# Access Compliance Report

## Public Rights-of-Way

Intersection ID: 20975	Main Street: DELSHIRE_LN	Cross Street: SANDY_PORTER_RD	Location: W
ADA ID: 247871B1E40B	Ramp Type: Directional1	Initial Pass/Fail: Fail	Overall Compliance: No
		Severity Score: 1.25

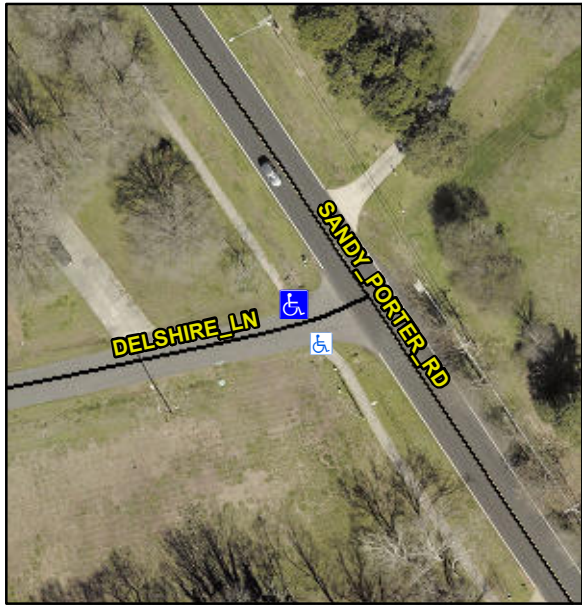
Codes/Mitigation Info/Possible Solution			Field Measurements/Component Compliance							
	Possible Solutions:		<b>Compliance</b>			<b>Description</b>			<b>Data</b>	
	<b>Remove &amp; Replace Entire Ramp.</b>		<b>N/A</b>	Ramp Length (in)	<b>66.0</b>	<b>N/A</b>	Grade Break?	<b>N/A</b>		
			<b>Yes</b>	Ramp Width (in)	<b>64.0</b>	<b>N/A</b>	Grade Break Slope (%)	<b>0.0</b>		
			<b>Yes</b>	Ramp Slope (%)	<b>2.7</b>	<b>N/A</b>	Grade Break XSlope (%)	<b>0.0</b>		
			<b>No</b>	Ramp XSlope (%)	<b>3.3</b>					
			<b>N/A</b>	Flare Type LT	<b>N/A</b>	<b>N/A</b>	Flare Type RT	<b>N/A</b>		
			<b>N/A</b>	Flare Slope LT (%)	<b>N/A</b>	<b>N/A</b>	Flare Slope RT (%)	<b>0.0</b>		
			<b>N/A</b>	Flare Traversable LT?	<b>N/A</b>	<b>N/A</b>	Flare Traversable RT?	<b>N/A</b>		
			<b>N/A</b>	Landing Length (in)	<b>0.0</b>	<b>N/A</b>	DWS Provided?	<b>N/A</b>		
			<b>N/A</b>	Landing Width (in)	<b>0.0</b>	<b>N/A</b>	DWS Contrast?	<b>N/A</b>

<b>N/A</b>	Landing Slope (%)	<b>0.0</b>	<b>N/A</b>	DWS Length (in)	<b>N/A</b>			
		<b>N/A</b>	Landing X Slope (%)	<b>0.0</b>	<b>N/A</b>	DWS Full Width?	<b>N/A</b>			
		<b>N/A</b>	Landing Curb? (Y/N)	<b>N/A</b>	<b>N/A</b>	DWS Offset LT (in)	<b>N/A</b>			
		<b>N/A</b>	Shared Landing?	<b>N/A</b>	<b>N/A</b>	DWS Offset RT (in)	<b>N/A</b>			
		<b>N/A</b>	Gutter Ponding?	<b>0.0</b>	<b>N/A</b>	Gutter Slope (%)	<b>N/A</b>			
		<b>N/A</b>	Gutter Lip Ht (in)	<b>0.0</b>	<b>N/A</b>	Gutter X Slope (%)	<b>N/A</b>			
		<b>N/A</b>	Painted X Walk1?	<b>No</b>		Road Slope (%)	<b>1.4</b>			
			X Walk 1 Direction	<b>To SE</b>		Road X Slope (%)	<b>2.7</b>			
			X Walk 1 Width (in)	<b>N/A</b>		Clear Space?	<b>N/A</b>			
			X Walk 1 Slope (%)	<b>1.4</b>	<b>N/A</b>	Clear Space to XWalk (in)	<b>N/A</b>			
			X Walk 1 X Slope (%)	<b>2.7</b>	<b>N/A</b>	Storm Grate/Utility Hazard?	<b>N/A</b>			
		<b>N/A</b>	Ramp inside XWalk1?	<b>N/A</b>		Storm Grate/Utility Type

<b>N/A</b>	Any Obstructions?	<b>N/A</b>			<b>N/A</b>			
			Obstruction Type		<b>Yes</b>	Surface Condition? (G/P)	<b>Good</b>			
					<b>N/A</b>	Curb Slope (%)	<b>5.7</b>			
Surveyor Notes:										
<b>N/A</b>										
PROW/ADA:										
<b>R304.5.3</b>										
Total Cost:		<b>\$</b>	<b>1600.00</b>							
Street 1 Name		<b>DELSHIRE LN</b>								
Stop Condition-Street 1		<b>StopSign</b>								
Street 2 Name		<b>N/A</b>								
Stop Condition-Street 2		<b>N/A</b>
